CONDITIONS OF APPROVAL:

Engineering - Final Plat Checklist

2019-09-05 755638 HUFFINES RIDGE PUD SUBDIVISION PLAT.pdf

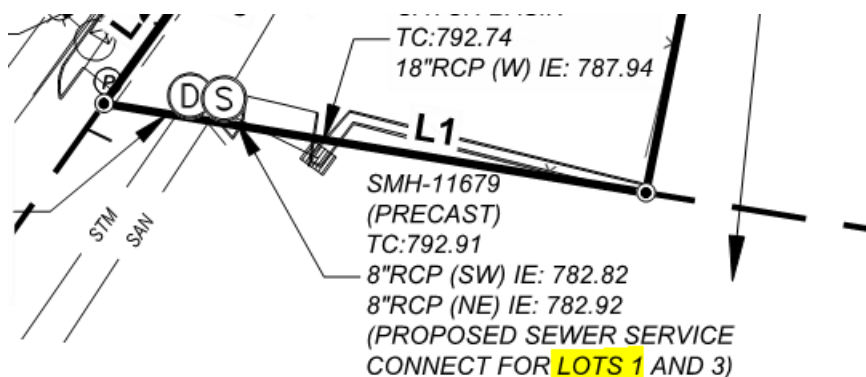
lance.fittro@franklinton.gov Applicant shall remove Lot 1 from the note shown below:

In addition to the understood sewer service connection for Lot 3 into the manhole, the note indicates a sewer service for Lot 1, which is located on the opposite side of Carothers Parkway, is proposed to connect to the manhole shown. However, a private sewer service will not be permitted to extend under Carothers Parkway to make this connection. Serving Lot 1 with sanitary sewer from this manhole would require a public main extension, with manhole set on the west side of Carothers Parkway, to which future services could be connected. Applicant shall remove reference to Lot 1 from this note to avoid future confusion.
